REVISED RESPONSE TO REQUEST FOR ADDITIONAL INFORMATION

APR1400 Design Certification

Docket No. 52-046

RAI No.: 45-7883
SRP Section: 07.09 – Data Communication System
Application Section: 07.09
Date of RAI Issue: 06/23/2015

Figure 4.1-1 Credible Failure Boundary of Control System CCF

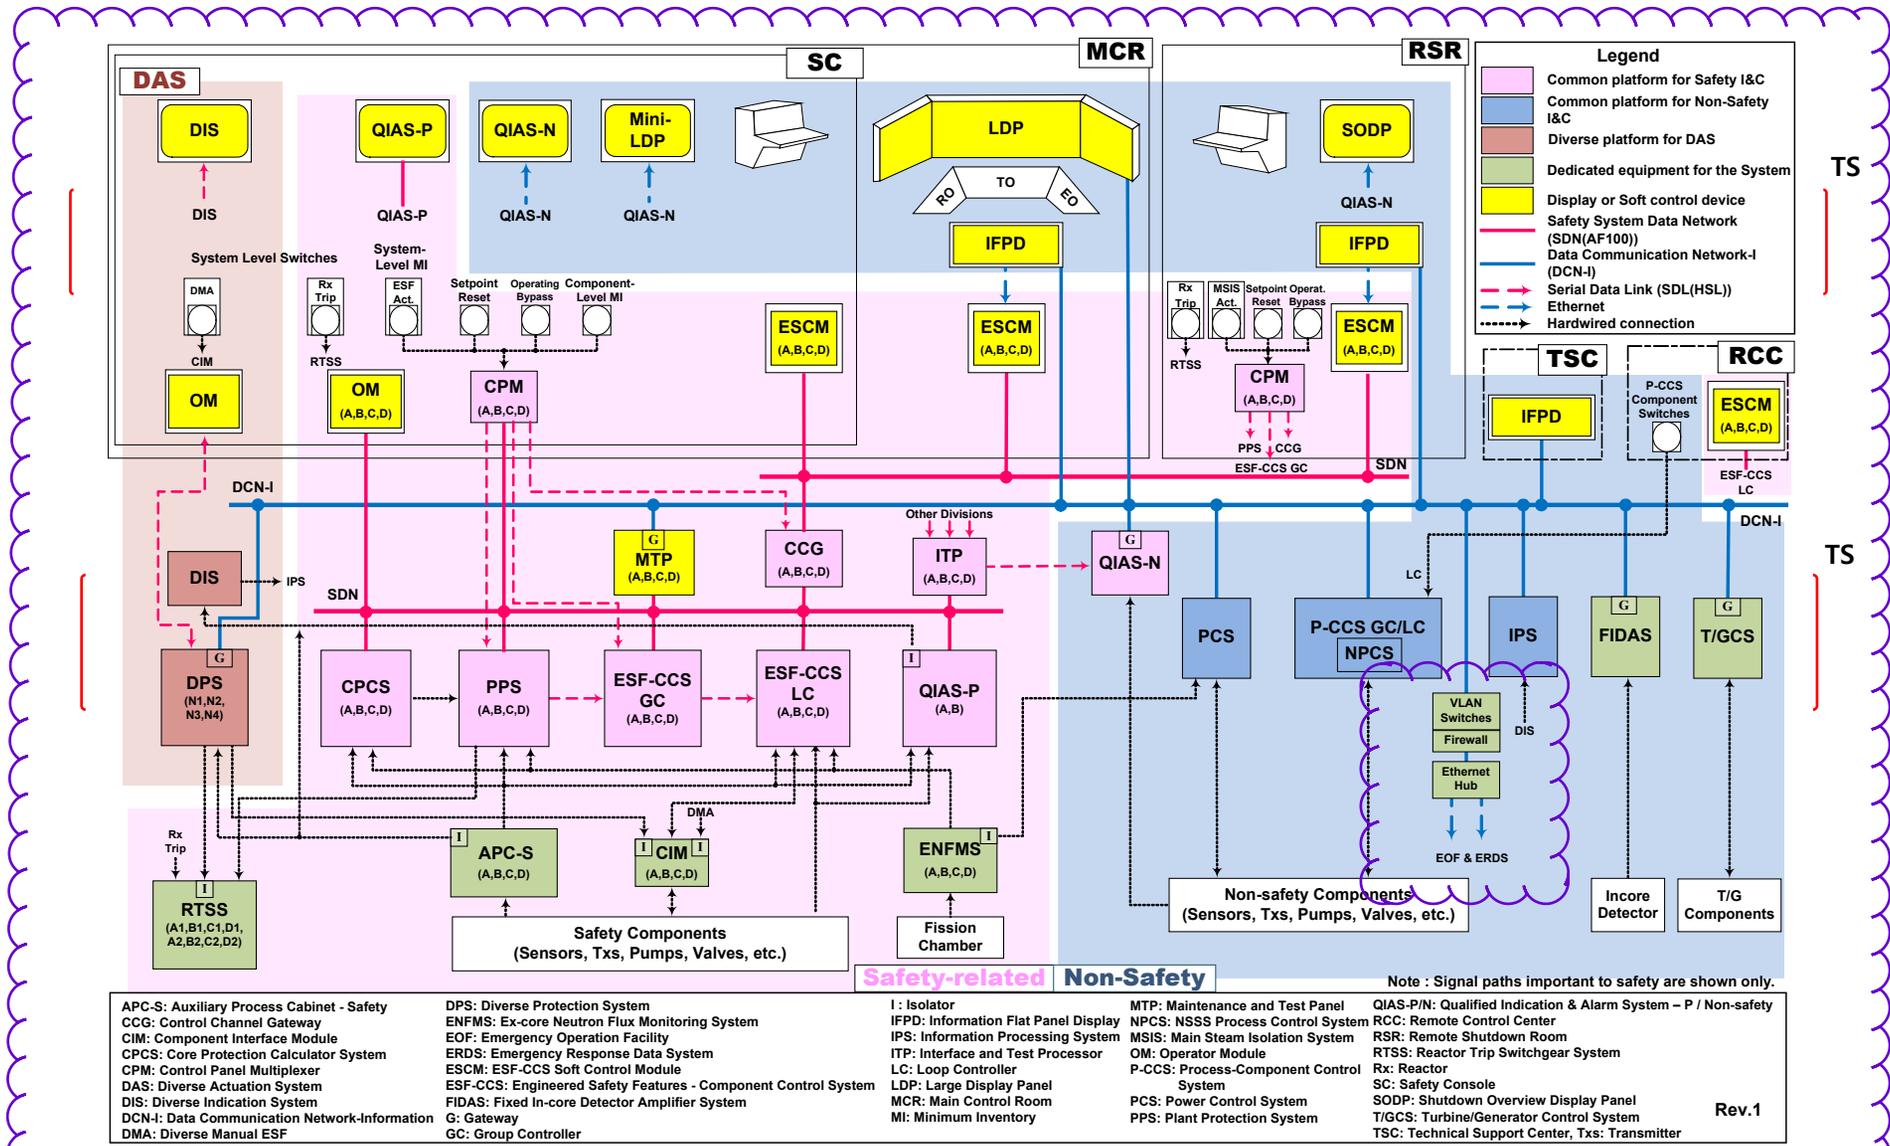
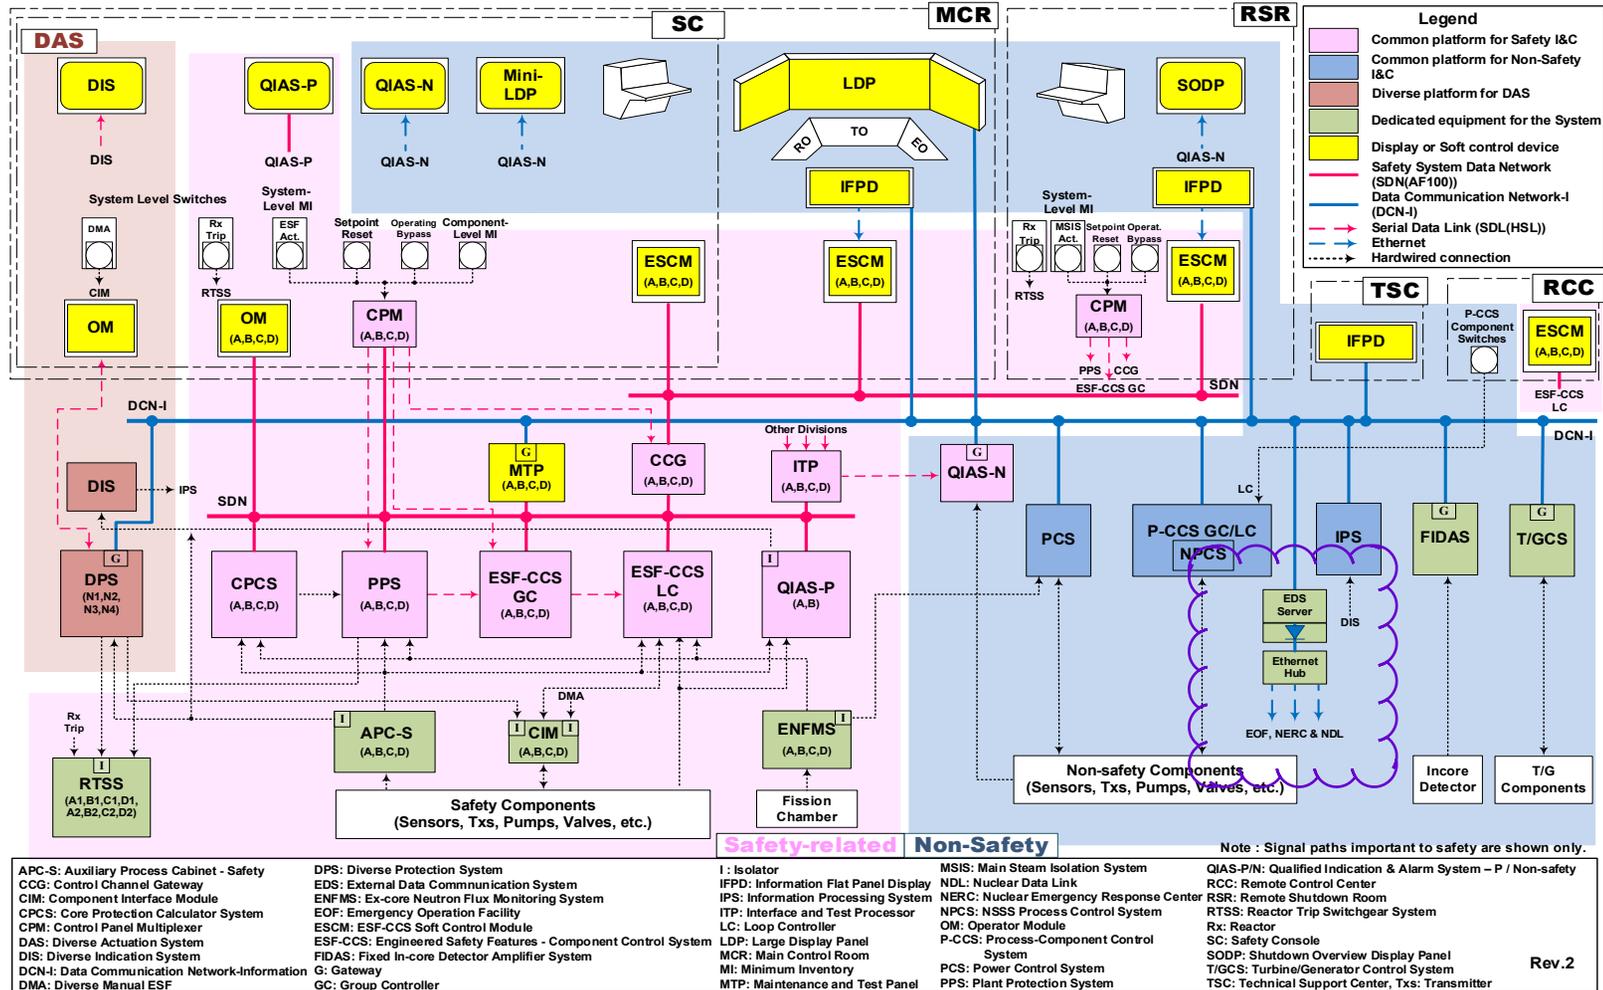
Figure 4.1-1 Control System CCF Analysis TeR will be revised as indicated in the attached mark-up.

Replace "F" on the following page
